Patent No.: 6,967,424

Title: ROTOR ASSEMBLY AND STATOR ASSEMBLY FOR AN ELECTRICAL MACHINE

**REQUEST FOR CERTIFICATE OF CORRECTION**  
**PURSUANT TO 37 C.F.R. § 1.323**

Fig. 1

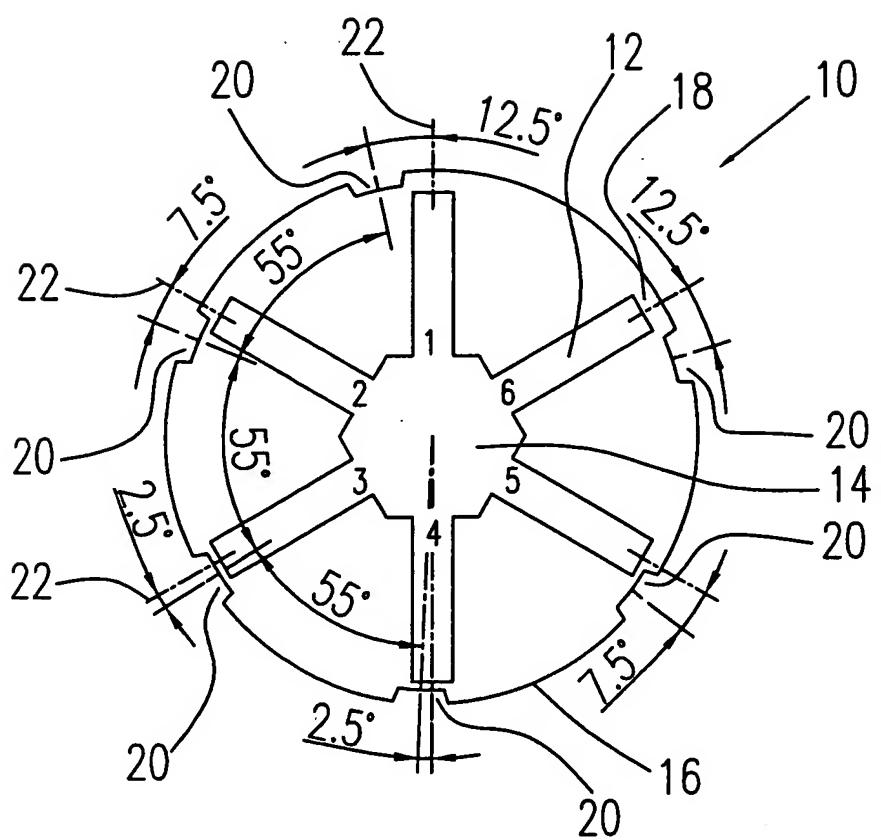
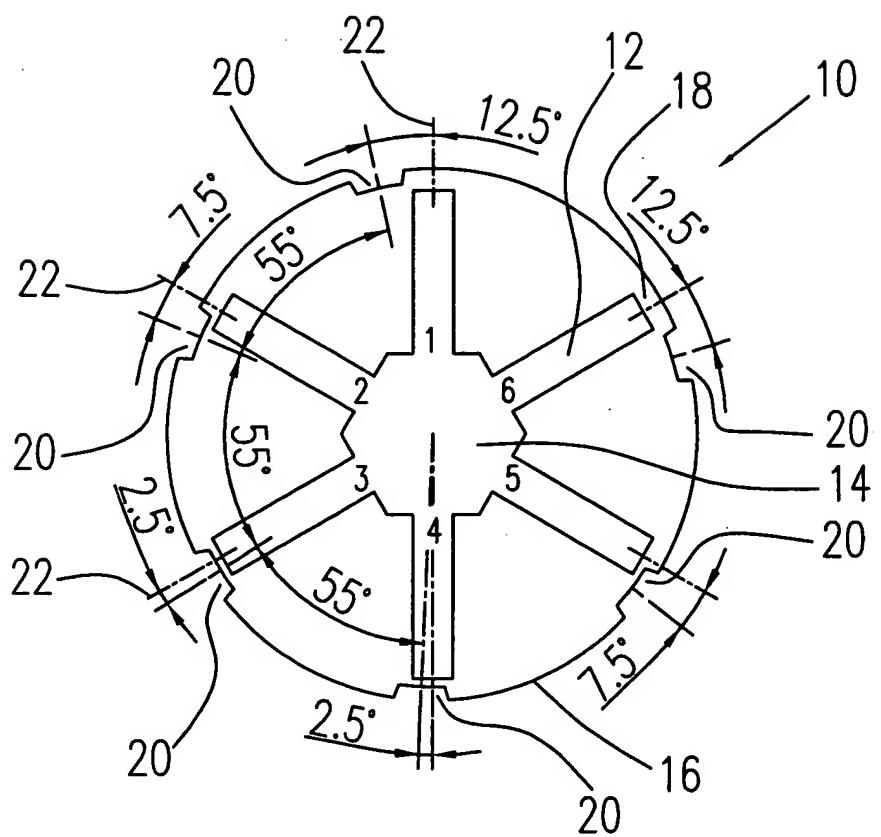
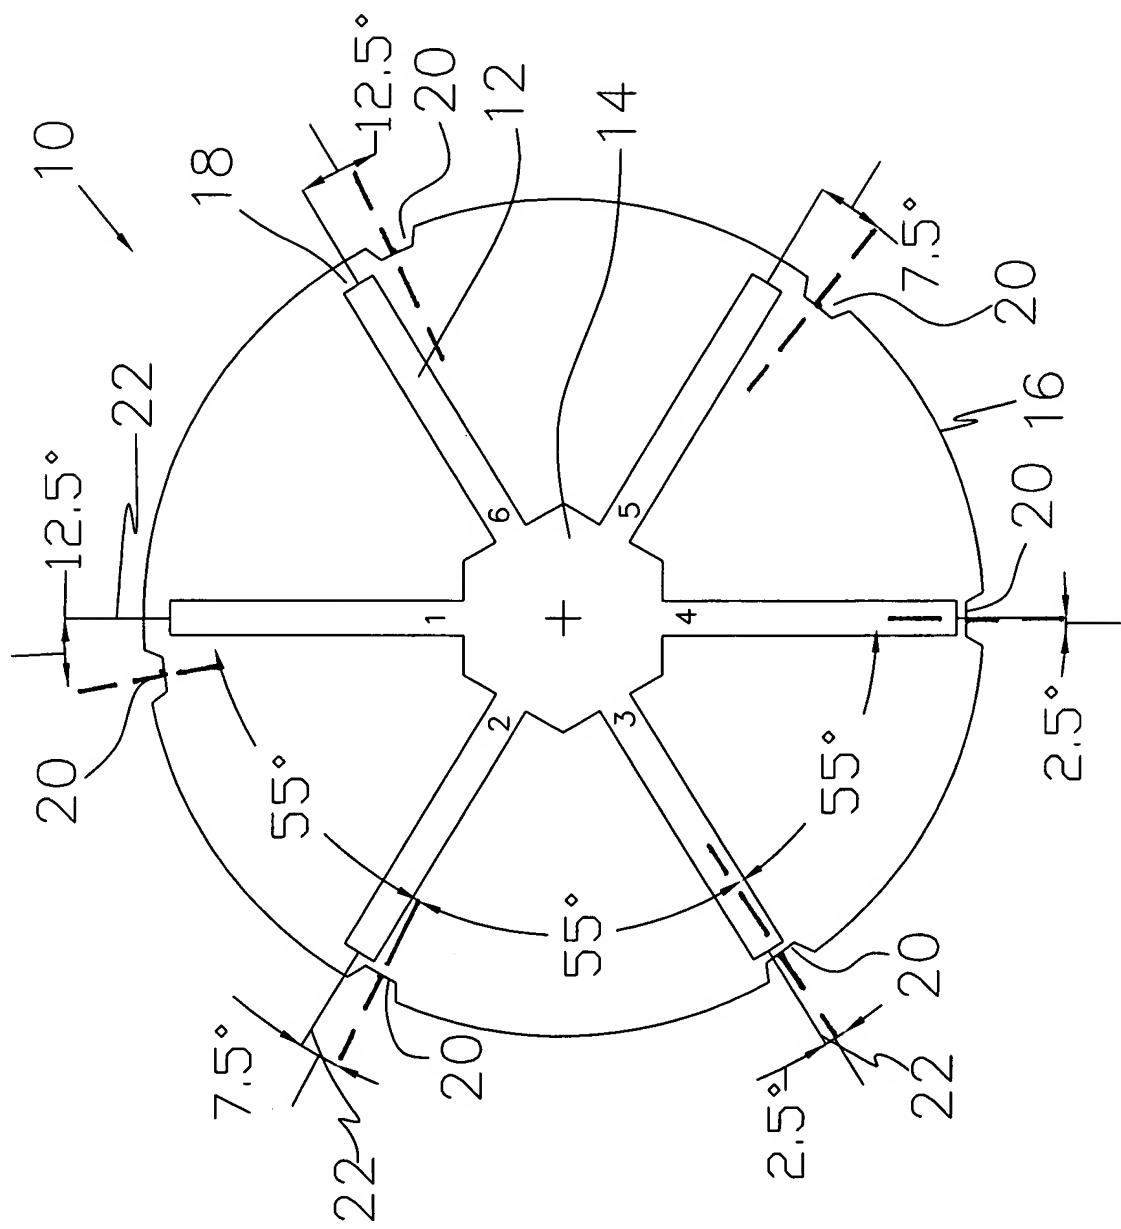
in Figure 1 show the angles indicated as 2.5, 7.5 and 12.5 degrees measured between the center line of the slots 12 and the center line of the shallow notches 20. A corrected Figure 1 is shown on page 2 of 3;

Fig. 2a

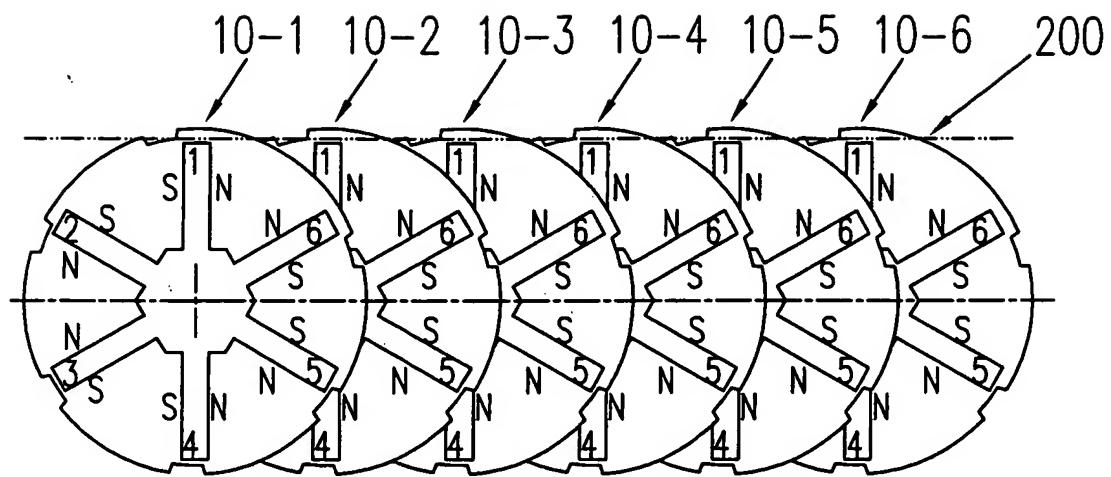
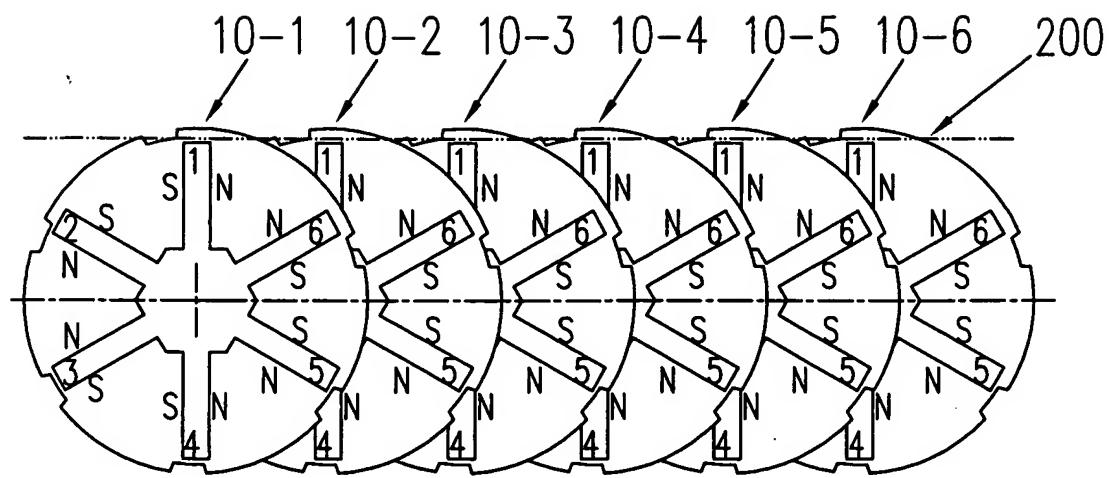
in Figure 2a show groove 200 to be in the same tangential position with regard to the slots of laminations 10-1, 10-2, 10-3, 10-4, 10-5 and 10-6. A corrected Figure 2a is shown on page 3 of 3; and

Fig. 2b

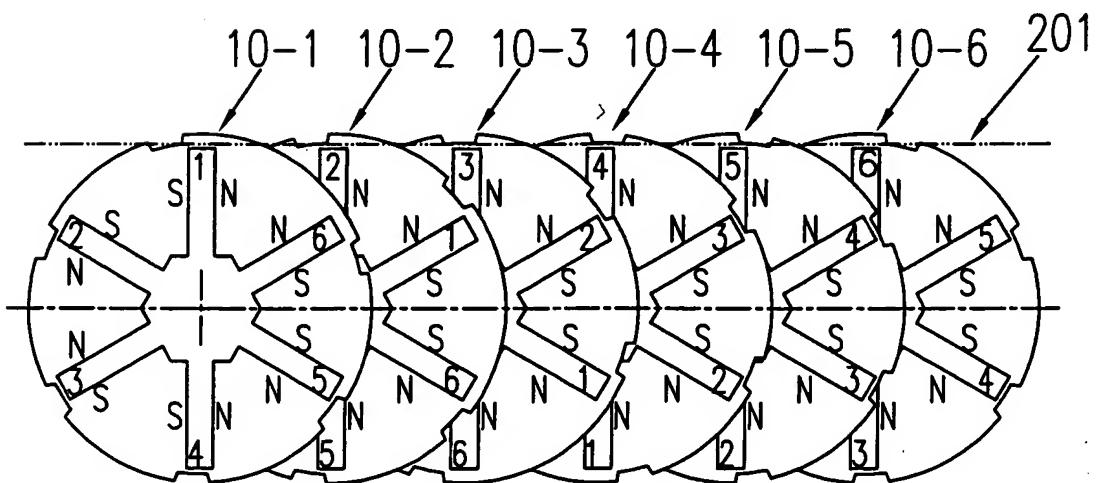
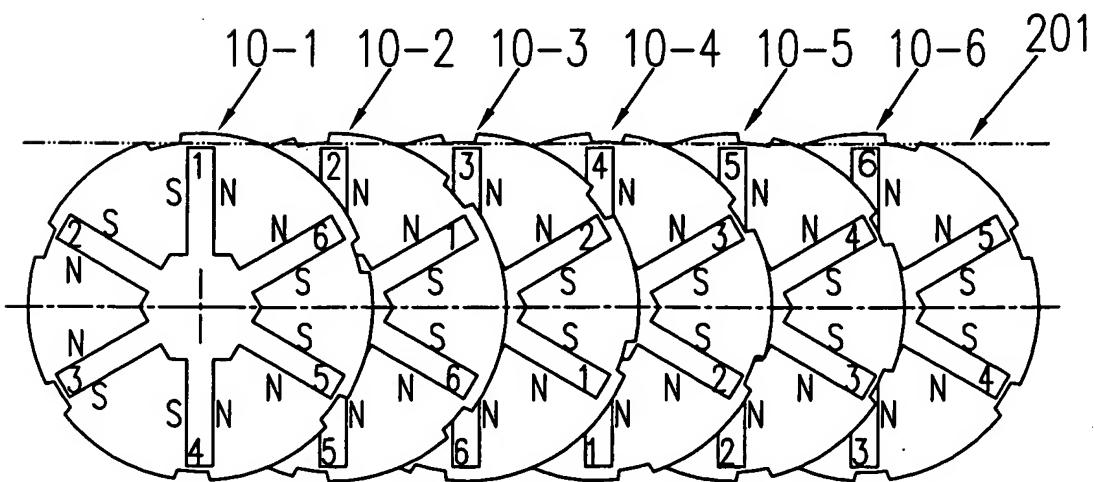
in Figure 2b show groove 201 to be in the same tangential position with regard to the slots of laminations 10-1, 10-2, 10-3, 10-4, 10-5 and 10-6. A corrected Figure 2b is shown on page 3 of 3.
